Marysville No. 5 Ellison 2024 Replat KPB File 2023-143 Seabright Surveying / Ellison Location: School Avenue & Marysville Street Anchor Point Area / Anchor Point APC

## ITEM #3 - PRELIMINARY PLAT Marysville No 5 Ellison 2024 Replat

KPB File No.	2023-143
Plat Committee Meeting:	January 8, 2024
Applicant / Owner:	Jeffery & Sharon Ellison of Anchor Point AK
Surveyor:	Katherine Kirsis / Seabright Survey + Design
General Location:	School Ave & Marysville St in Anchor Point APC

#### **STAFF REPORT**

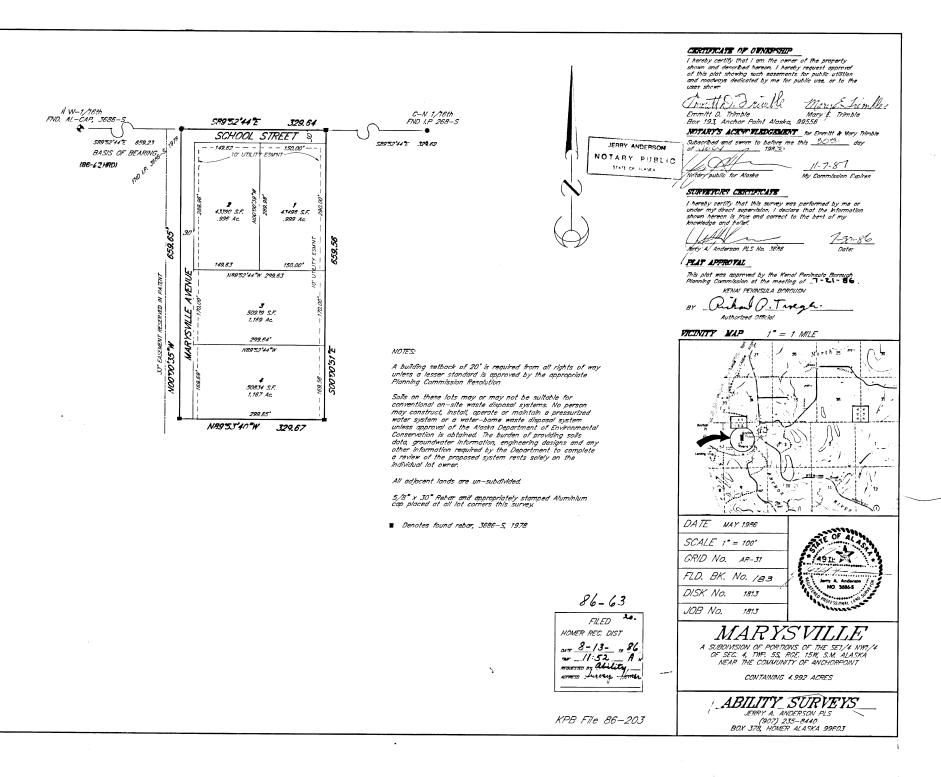
In the title block change KPB File No to 2023-143 Reduce scale of vicinity map to better show location information

**Staff recommendation**: comply with 20.60.190. Add the date of January 8, 2024 to the Plat Approval
